Final Lake Tahoe Total Maximum Daily Load

Nevada Division of Environmental Protection
901 South Stewart Street, Suite 4001
Carson City, Nevada, 89701-5249

August 2011

18 Appendix B – Responses to Peer Reviews

Figure 2-1. Location of the Lake Tahoe basin (USACE 2003).

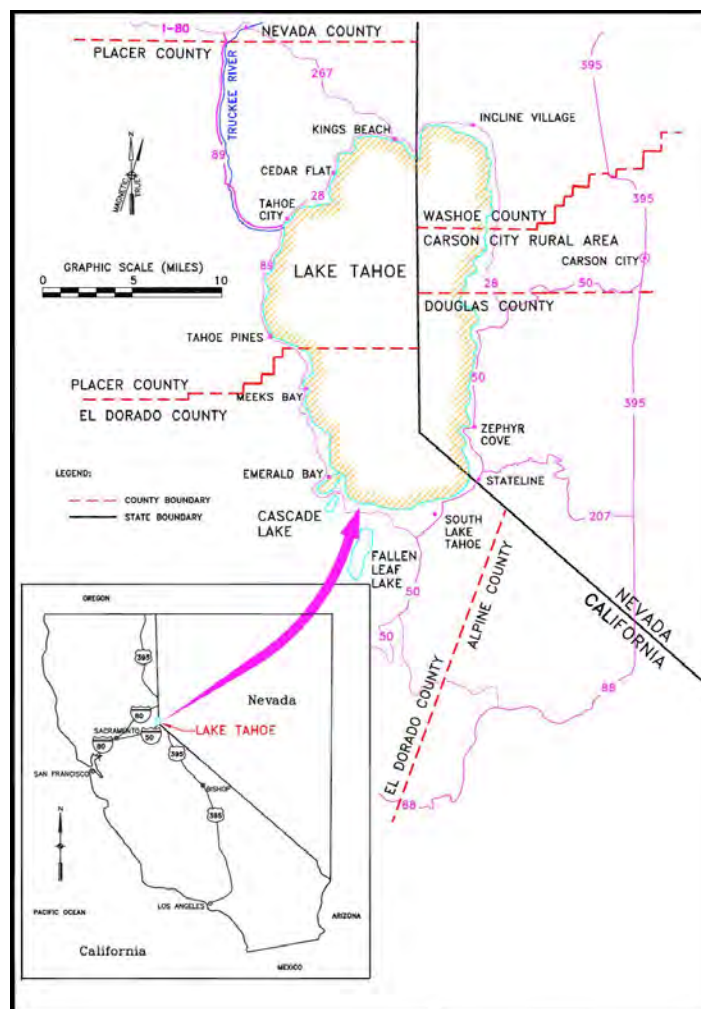
Page	¶/Line	Comment
ES-2	4fb	It would be clearer if the values were given as percentages of the required reduction (e.g., $24.5 \times 100 / 32 = 76.5\%$ of the reduction should come from urban uplands.)
2-1		The map (Figure 2-1) is not very helpful. It is unclear where the line between CA and NV is. It is not clear that the unnamed area on the NW end of the lake is a part of

- 8fb Should be Tables 10.5 through 10.7
- 6fb Should be Tables 10.2 through 10.4
- 11-7 16fb County is identified as Ormsby on Figure 2-1.
- 14 Appears to be some missing text at end of line.

PB-21: The location map, Figure 2-1 in the Final Report has been replaced with a more accurate figure.

- PB-31:** The Figure 2-1 has been replaced, the text is correct, it is Carson City Rural County.
- PB-32:** The text has been removed and/or corrected for Chapters 9-11.

Figure 3-1. Relationship between in-lake particle number (< 16 μm) and Secchi depth with P-value = 0.001 and $R^2 = 0.057$ (modified from Swift 2004).

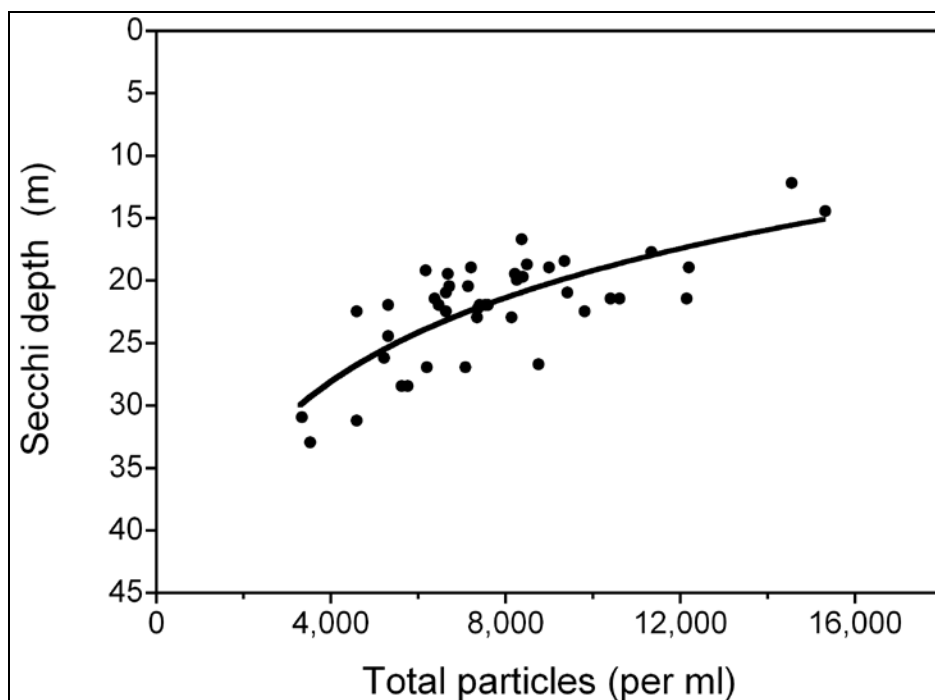
4. The text associated with Figure 3-1 is erroneous, as is the figure itself. The text states that water does not absorb light. This is patently incorrect (see TMDL technical report). Pure water absorbs light and also scatters light. The proportion of light absorbed or scattered depends on wavelength. Particles also both absorb and scatter light, and do so differentially with respect to wavelength. Although the diagram in Figure 3-1 comes from a reputable study (PhD dissertation), it apparently misled the author of the TMDL draft, and should be either corrected or eliminated.

WL-3: The text was modified in the Final Report, Section 3.1; and the Technical Report, Section 3.4.1, to correct the discussion. The figure was removed from the Final Report (Figure 3-1) and the Technical Report (Figure 3-8).

Figure 3-2. Influence of particle size on light scattering (modified from Swift et al. 2006).

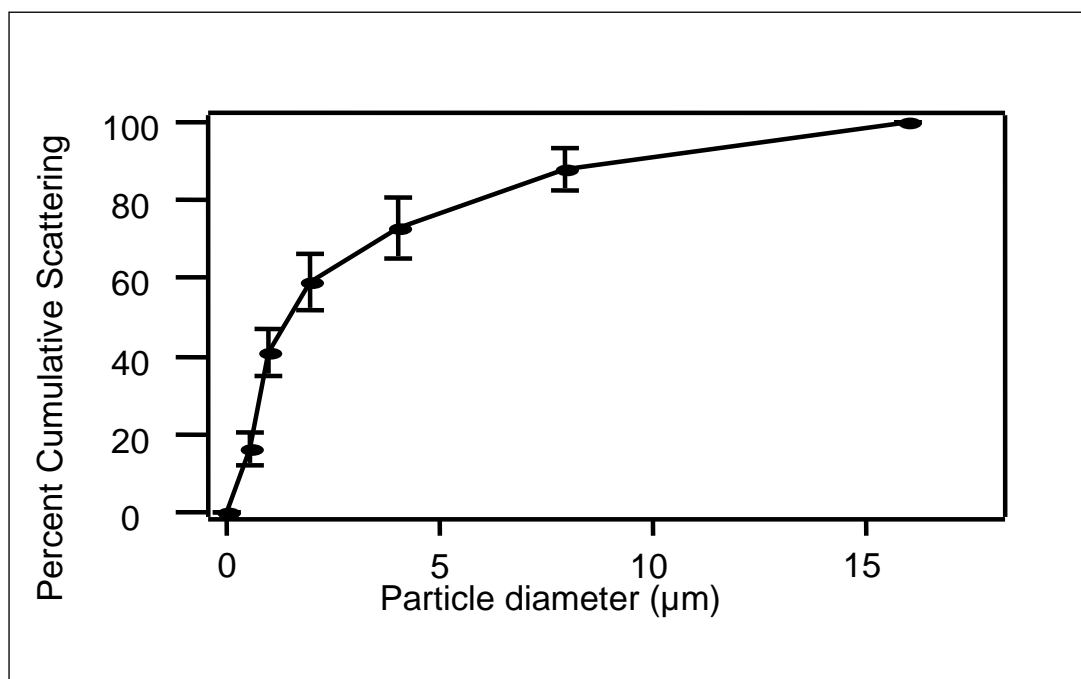
- 2-4 Fig. 3-2 Box indicates the line of best fit is a linear fit but the line clearly is curved. The best fit equation should be provided in the box.
- 6fb This is an understatement. The figure shows that ~70% of the scattering is due to particles < 5 μm in diameter.

What are the sizes of the particles represented in Figure 3-2?

PB-23: Figure 3-2 in the Final Report has been updated and the R² and p-value has been added to the caption.

JM-21: The size of particles represented in Figure 3-2 of the Final Report (and Figure 3-8 of the Technical Report) were particles <16 µm in diameter. This information was added to the appropriate figure captions.

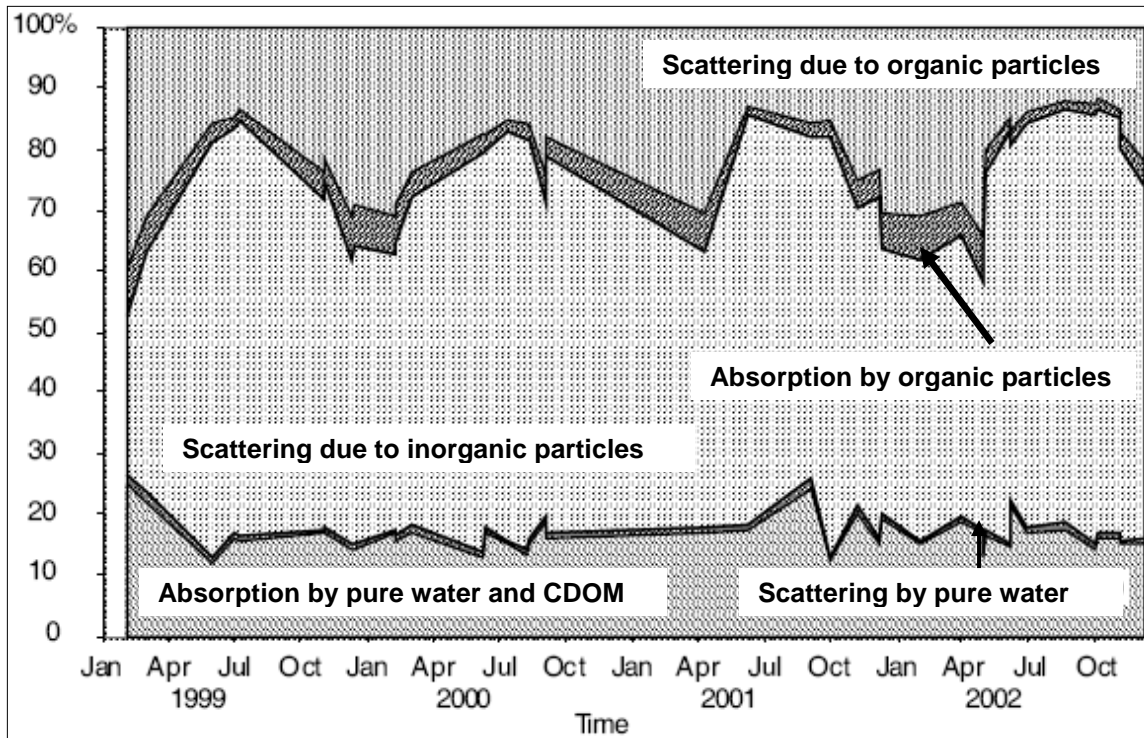
6. Figure 3.3 is difficult to interpret. What is the assumed abundance or mass per unit volume of particles upon which this graph is based? The graph is meaningless without a more complete explanation of the underlying assumptions or of the observations that are portrayed here.

Figure 3-4. Annual average primary productivity in Lake Tahoe from approximately 25-30 measurements per year (UC Davis – TERC 2008).

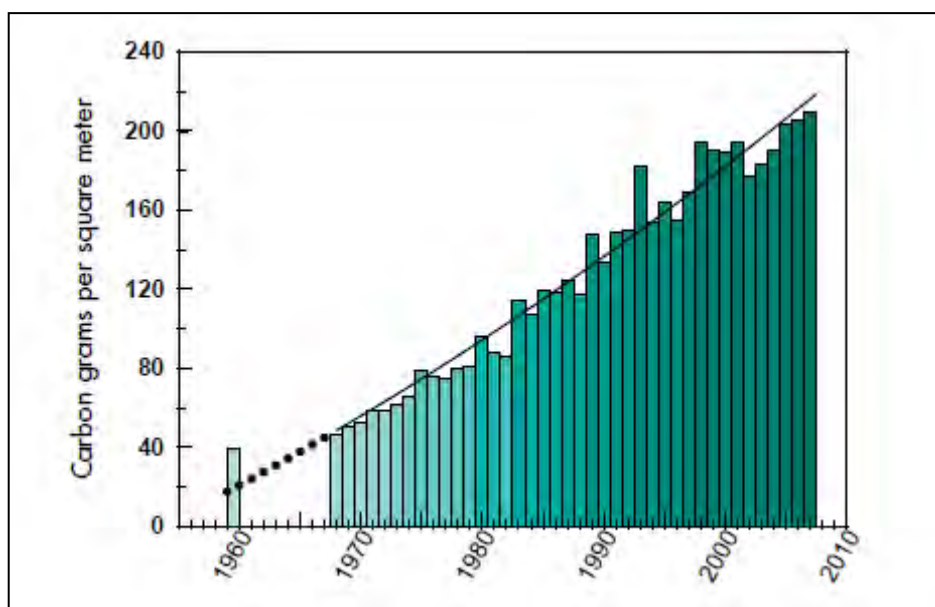
7. Figure 3-4 also cannot be easily interpreted based on the labels (see also TMDL technical report). The scattering effect of pure water is not labeled on the graph. Inorganic particles are labeled “sediment” although sediment is the name for all particles and not just inorganic particles. Organic particles are termed “algae” although it has already been stated that organic particles include other items.

WL-6: The figure and captions have been revised in both the Final Report (Figure 3-4) and Technical Report (Figure 3-11).

Figure 8-1. Conceptual Lake Clarity Model.

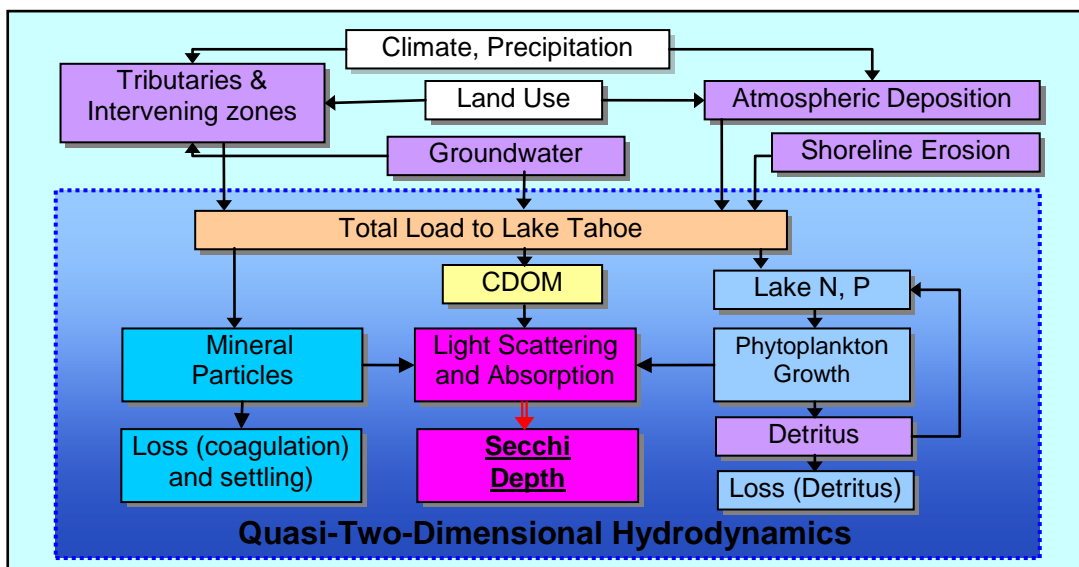
14. In Figure 8-1, the output of the upper part of the flow diagram is shown as total pollutant load. Actually, this load is more correctly referred to as total load. Only a portion of this total is traceable to pollution. We cannot count every ounce of phosphorus, nitrogen, or suspended solids as pollution. Also, in the same diagram, there is a reference to CDOM, which comes in from the watershed mostly. It is good to have this component in the model, but the means of estimating it is not given in the text, nor is any information given on the treatment of CDOM in the model.

WL-12: Not all nutrient and fine sediment loading to Lake Tahoe (and to other waterbodies) is a pollutant. The word 'pollutant' was removed from Figure 8-1 in the Final Report and Figure 6-1 in the Technical Report. The term 'pollutant' is used in the TMDL to include both the nutrient and sediment material because the TMDL allows for reduction of these materials regardless of its ultimate source (i.e. surface runoff can include both anthropogenic and natural sources) and treatment/control applies to the combined load. The CDOM (colored dissolved organic matter) term in the conceptual model (Figure 8-1 Final Report) is supported by laboratory experiments using water from Lake Tahoe. The value used in the model for absorption due to CDOM is given in Table 6-4 in the Technical Report along with a reference.

Figure 8-2. Measured and modeled Secchi depths for 2000-2020. The close agreement during the period between 2000-2005 between field data and modeled output highlight utility of the Lake Clarity Model (Sahoo et al. 2009).

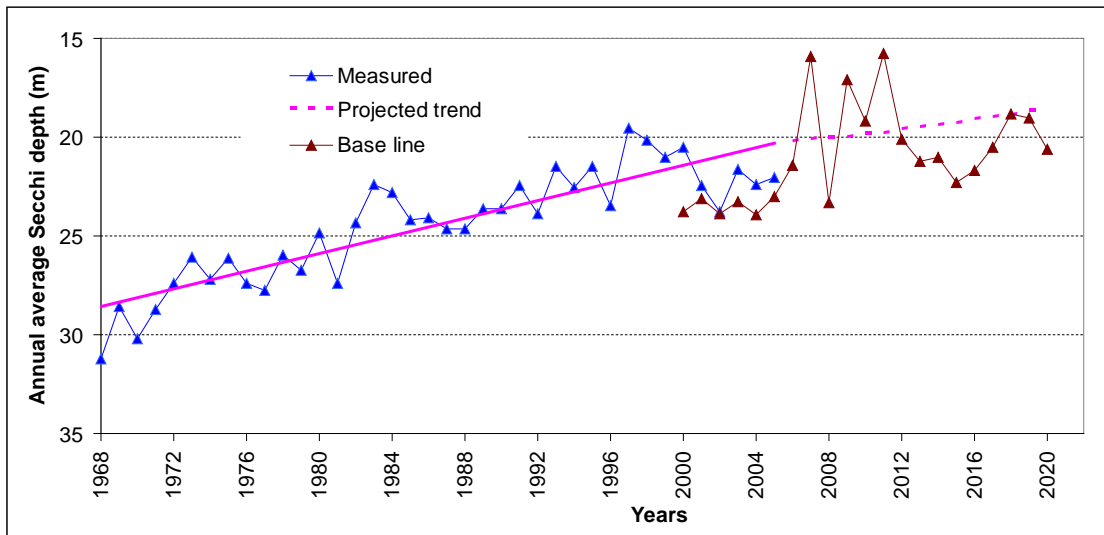
16. Figure 8.2 also poses some problems. Years 2000-2005 are reported to show good agreement, but there are some reasons to question this conclusion, as mentioned above. More troubling is the very wide variation of predicted secchi depths after 2005. The range of variation seen here for predictions is not found anywhere in the previous record of observed secchi depths. Certainly secchi depth observations must

Figure 13-1. Sampling locations for LTIMP Stream and Lake (TERC) sites (Tetra Tech unpublished). The Index Station is the TERC Monitoring Station that is near the west shore, it is located 2km from the shore and is positioned over deep water (greater than 100 meters deep).

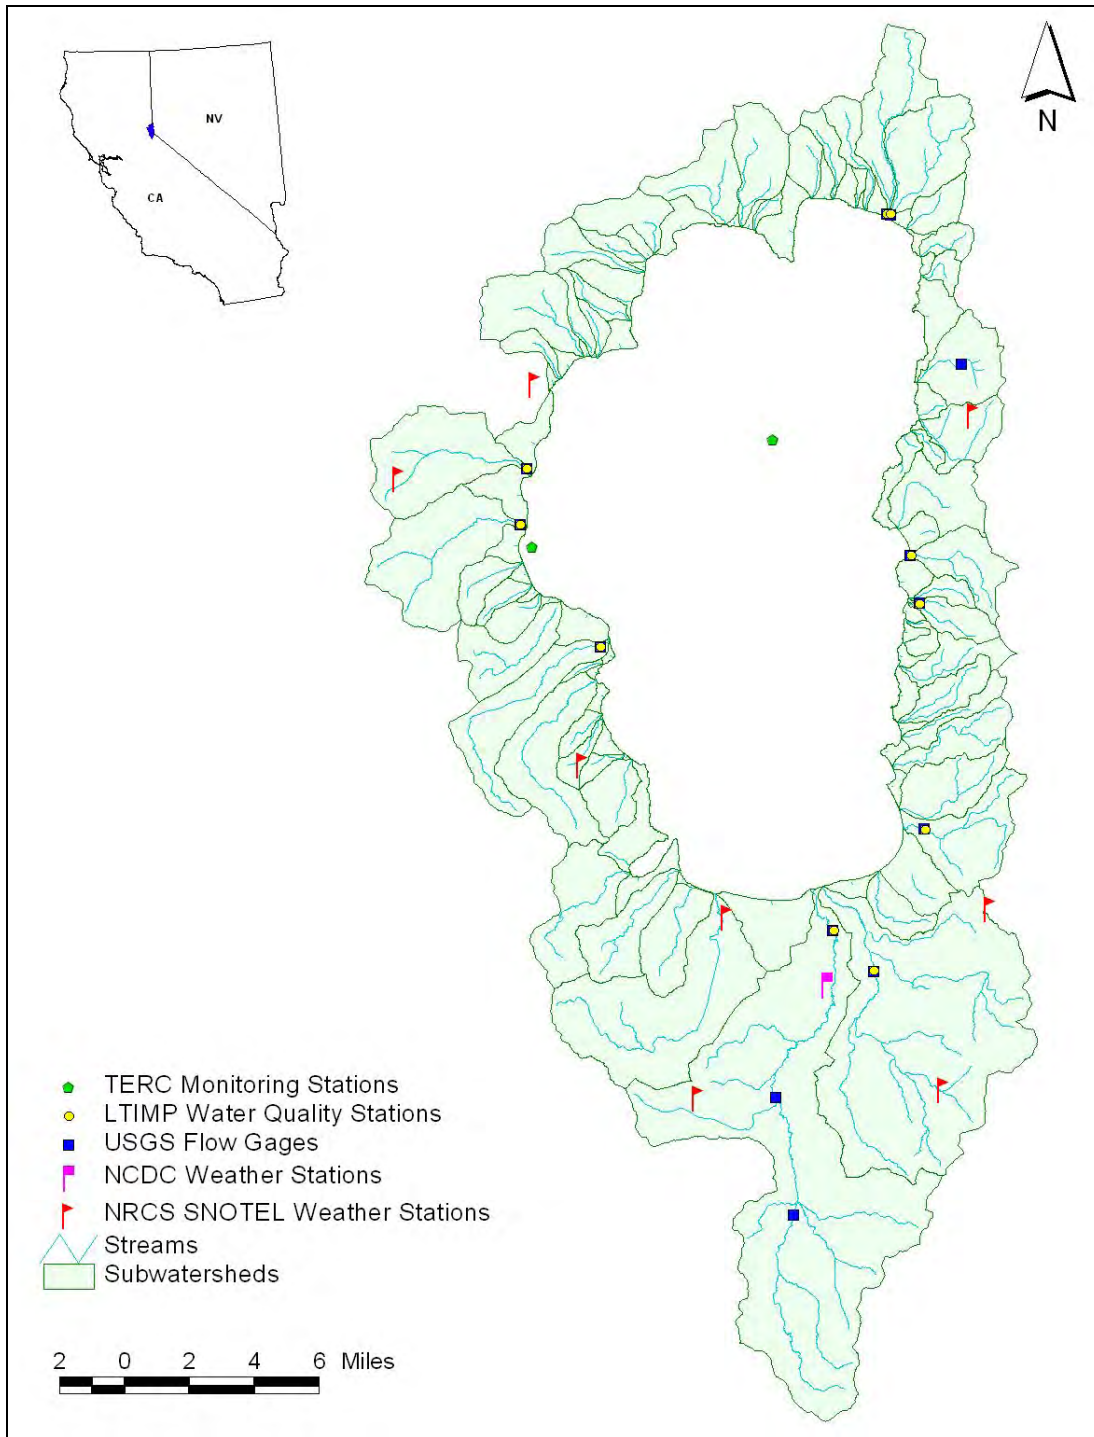
- 13-7 Last ¶ The text should say how far from shore the index station is. The map in Figure 13-1 shows the station as very close to the shore. Text elsewhere indicates the station is 2 km from shore. The figure may need to be corrected, and it would be useful to label each TERC station on the map.
